Project	IEEE 802.16 Broadband Wireless Access Working Group http://ieee802.org/16 >	
Title	Spectrum Mask Proposal	
Date Submitted	2005-07-10	
Source(s)	Mats Samuelsson, Sten Sjoberg, Havish Koorapaty Ericsson Inc., 8001 Development Drive, RTP NC 27709	Voice: +1 (919) 472-7524 Fax: +1 (919) 472-6554 mailto:havish.koorapaty@ericsson.co m
Re:	Document to support non-binding comment to sponsor ballot for IEEE P802.16/Cor1/D3	
Abstract	This document proposes a spectrum mask requirement for IEEE 802.16-2004	
Purpose	The document is intended for consideration in comment resolution process of the Sponsor Ballot on draft 802.16-2004/Cor1/D3	
Notice	This document has been prepared to assist IEEE 802.16. It is offered as a basis for discussion and is not binding on the contributing individual(s) or organization(s). The material in this document is subject to change in form and content after further study. The contributor(s) reserve(s) the right to add, amend or withdraw material contained herein.

Spectrum Mask Proposal

Proposed Text Changes

Figure 212a

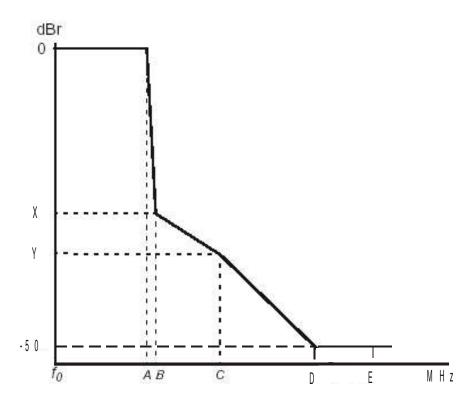
Insert new section 8.3.10.3 on page 88 of draft 802.16-2004/Cor1/D3 before section 8.3.11 as follows.

For licensed bands, the transmitted spectral density of the transmitted signal shall fall within the spectral mask shown in Figure 212a. The measurements shall be made using 100 kHz resolution bandwidth and a 30 KHz video bandwidth. The 0 dBr level is the maximum power spectral density allowed by the relevant regulatory body.

In Figure 212a,

X = -25 dB for SS and -32 dB for BS

Y = -32 dB for SS and -38 dB for BS

A = 0.475 F

B = 0.545 F

C = 0.975 F

D = 1.475 F

E=2.4 F

F= channel bandwidth

Figure 263a

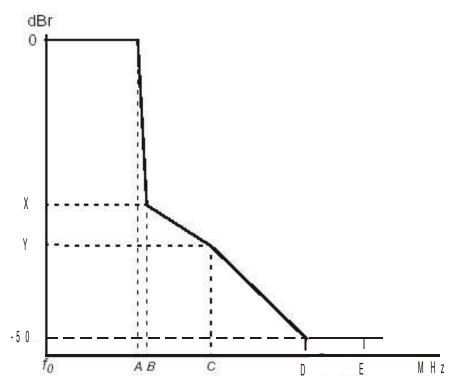
Insert new section 8.4.12.4 on page 174 of draft 802.16-2004/Cor1/D3 before section 8.4.13 as follows.

For licensed bands, the transmitted spectral density of the transmitted signal shall fall within the spectral mask shown in Figure 212a. The measurements shall be made using 100 kHz resolution bandwidth and a 30 KHz

video bandwidth. The 0 dBr level is the maximum power spectral density allowed by the relevant regulatory body.

In Figure 263a,

X=-25 dB for SS and -32 dB for BS

Y=-32 dB for SS and -38 dB for BS

A = 0.475 F

B = 0.545 F

C = 0.975 F

D= 1.475 F

E=2.4 F

F= channel bandwidth
